APPENDIX E: ADDITIONAL INFORMATION PROVIDED BY WCPL

1. Response to OEH Submissions dated 28 June 2016
2. Letter from Hydro Simulations dated 7 July 2016
3. Letter regarding biodiversity offset matters dated 9 September 2016

**Table 1
Response to OEH Submission (16 June 2016) – Wilpinjong Extension Project (SSD 6764)**

Re: **Wilpinjong Extension Project – Response to Residual Matters
Raised by DPI Water**

Extract from Figure 5-8 (updated to 2016) – Comparison of Modelled versus Observed GWLs

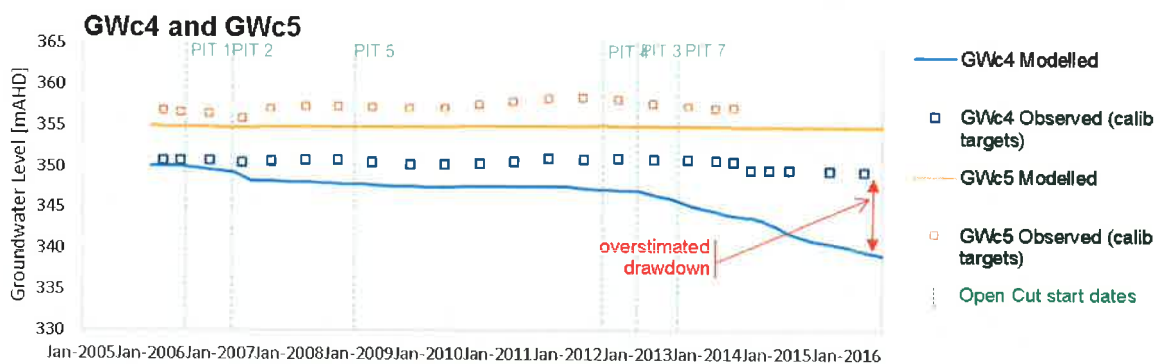
Modelled groundwater levels in the Ulan Coal seam (Figures 5-7 and 5-8 of the Groundwater Assessment) are a good match to observed, including the simulated drawdown around the WCM mine area (including at GWc28, GWc29). The model simulates that some drawdown will occur in the Ulan Coal seam extending north and east toward the Goulburn River (Figure 6-5 of the Groundwater Assessment). However, drawdown in the Ulan Seam is known to be an overestimate of observed drawdown at GWc4 (see Figure 5-8 – an update showing more recent data is included below), which is the bore furthest to the northeast of the WCM/WEP.

The raw model results suggested that the take from the Goulburn River alluvium would be small, with a maximum take of some 10 ML/a. Given the degree to which the drawdown in the Ulan Seam is overestimated to the north of the mine (see GWc4 hydrograph above), it is considered that the take in practice would be much less than the modelled maximum take of 10 ML/a, probably less than 1-2 ML/a given the difference in drawdown as shown on the above figure, which for licensing purposes is considered to be negligible. For comparison, the average Water Access Licence entitlement in the Upper Goulburn River Water Source is 104.4 ML/a (obtained from the NSW Water Register¹).

Notwithstanding the overestimate of drawdown, for licensing purposes, the recommended requirement for the Wollar Creek alluvium (Table 7-1 in the Groundwater Assessment) includes an extra 10 ML/a based on the logic that if the model overestimates take from the Goulburn River Water Source, then that water would have to be derived from the more proximal aquifer.

Figure 1 Electrical Conductivity trends in Wilpinjong Creek

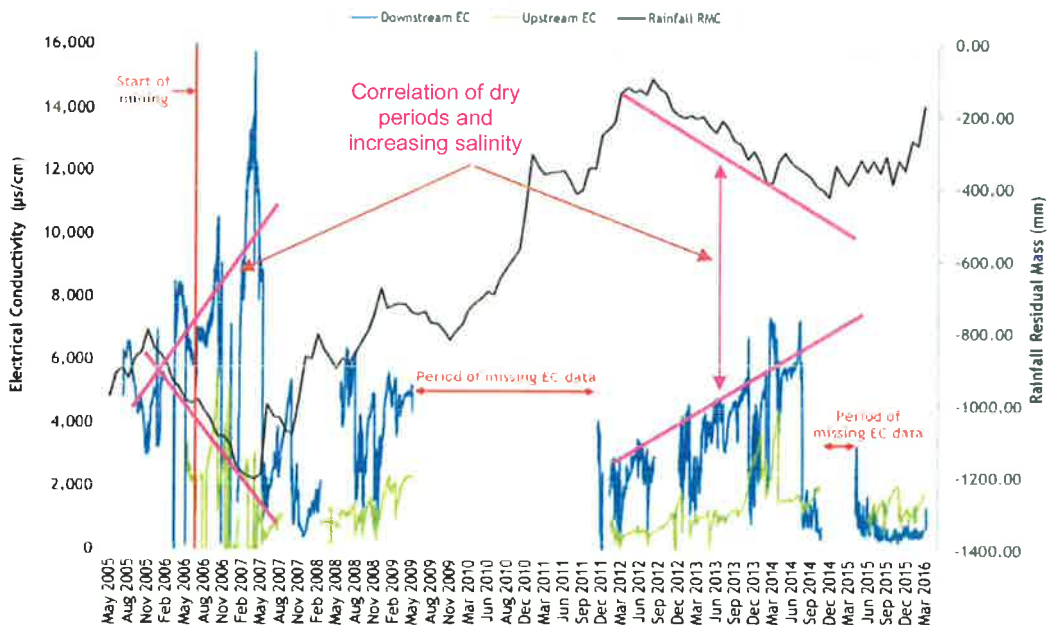
The average salinity in both is therefore considered to be 'marginal' to 'brackish'. At the upstream sites, the maximum observed EC is 730% of the average, while at the downstream sites the maximum is 275% of the average, illustrating the significant variation in salinity (also shown on **Figure 1**)².

Note that the statistics presented above are based on the full dataset to current day. Salinity before and immediately after the commencement of mining was actually higher than during mining salinity in Wilpinjong Creek as shown in **Figure 1** and in the accompany data file².

The average downstream salinity of Wilpinjong Creek has been adopted as the benchmark for evaluating impacts. This results in a conservative estimate of the % change in salinity for assessment against the AIP.
